ORDINANCE NO. 3947

AN ORDINANCE OF THE CITY COUNCIL OF THE CITY OF NORTH RICHLAND HILLS TARRANT COUNTY, TEXAS, AMENDING THE CODE OF ORDINANCES, NORTH RICHLAND HILLS, TEXAS, BY AMENDING CHAPTER 98, BUILDING AND BUILDING REGULATIONS, BY AMENDING SECTION 98-42 REMOVING REQUIREMENT FOR CONSTRUCTION CODE APPEALS BOARD TO REVIEW ALL AMENDMENTS TO THIS CHAPTER; AMENDING SECTION 98-92 AND SECTION 98-93 SETTING REGULATIONS FOR PERMIT FEES AND EXPIRATION OF PERMITS; AMENDING SECTION 98-141 AND SECTION 98-142 ADOPTING THE INTERNATIONAL RESIDENTIAL CODE, 2024 EDITION, WITH AMENDMENTS; AMENDING SECTION 98-143 AND SECTION 98-144 ADOPTING THE INTERNATIONAL BUILDING CODE, 2024 EDITION, WITH AMENDMENTS; AMENDING SECTION 98-145 AND SECTION 98-146 ADOPTING THE INTERNATIONAL ENERGY CONSERVATION CODE, 2024 EDITION, WITH AMENDMENTS; AMENDING SECTION 98-147 AND SECTION 98-148 ADOPTING THE INTERNATIONAL SWIMMING POOL & SPA CODE, 2024 EDITION, WITH AMENDMENTS; CREATING A NEW SECTION 98-149 AND SECTION 98-150 ADOPTING THE INTERNATIONAL EXISTING BUILDING CODE, 2024 EDITION, WITH AMENDMENTS; CREATING A NEW SECTION 98-151 AND SECTION 98-152 ADOPTING THE INTERNATIONAL FIRE CODE, 2024 EDITION, WITH AMENDMENTS;

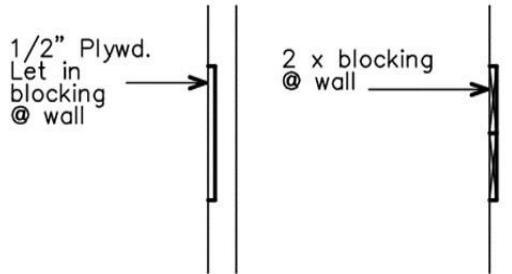
R327.3 Blocking Locations; add to read as follows:

R327.3 Blocking locations. Required at one toilet at grade level with blocking installed at rear wall and, if available, one wall adjacent to toilet and at one tub or shower at grade level. Blocking as shown in Figure R327.3.

R327.4 Wall Blocking; add to read as follows:

R327.4 Wall Blocking. Blocking may be $\frac{1}{2}$ " plywood or 2 x solid wood blocking or equivalent, flush with wall as shown in Figure R327.4.

Figure R602.6(1) is amended to appear and read as follows:

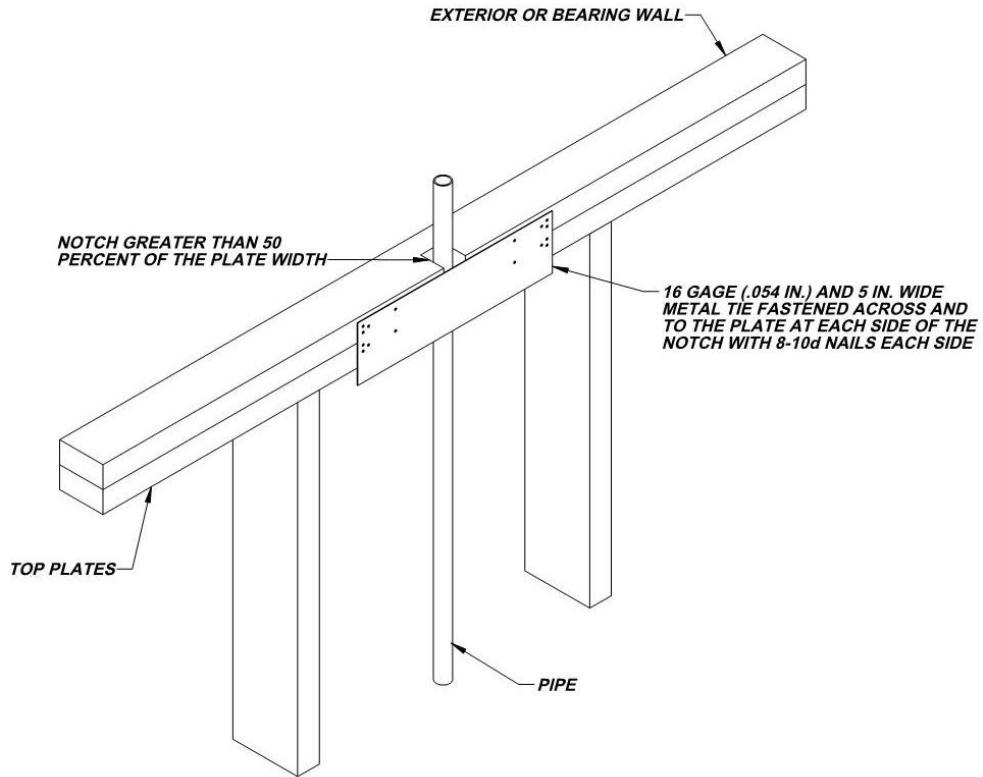
Plumbing in walls and bottom & top plates. Any plumbing in a stud wall and bottom/top plate that is 2" and larger shall be installed in a 2" x 6" stud wall and top/bottom plates.

ADD: Figure: 25 TAC §265.186 (e) (6)

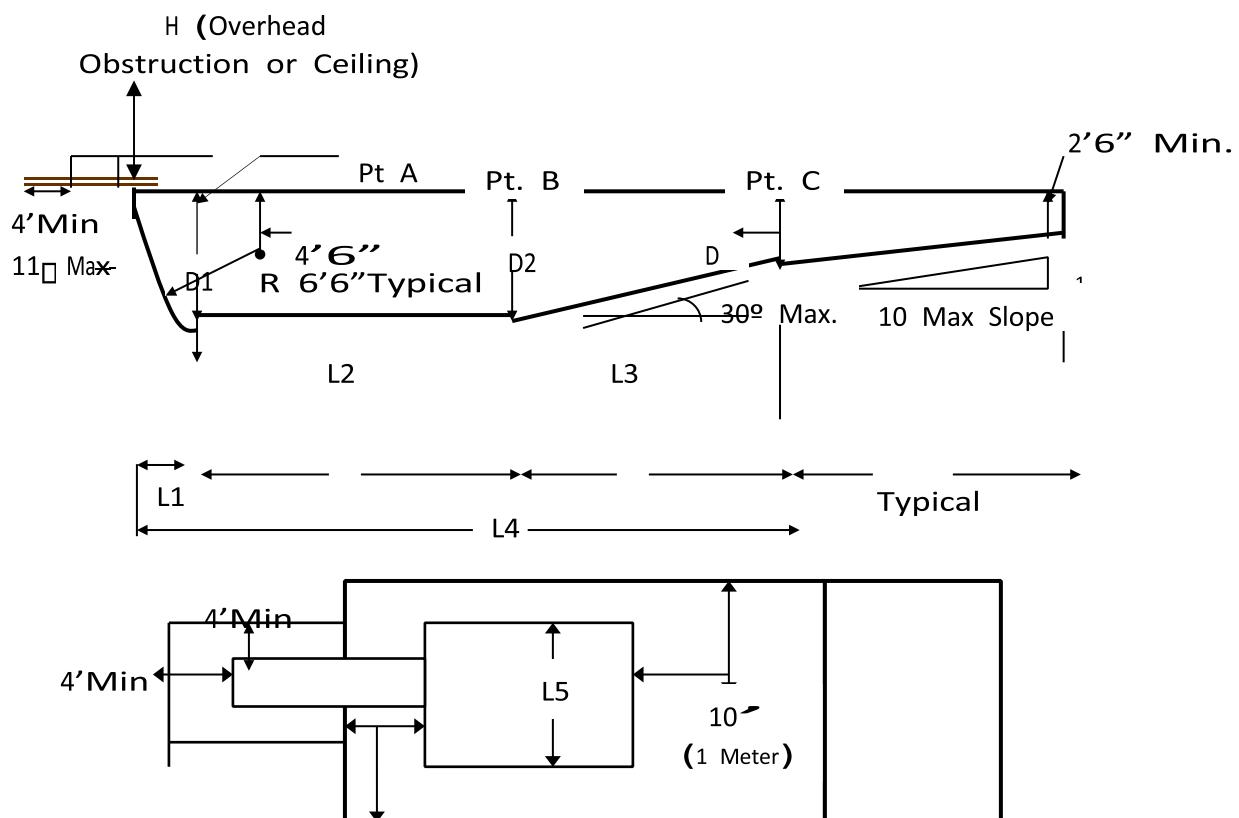
Section 402.12; Change to read as follows:

Texas department of State Health services, Administrative Code Title 25, Chapter 265, Section 186(e) and Figure: 25 TAC 256.186(e)(6). (Delete table 402.12 and Figure 402.12
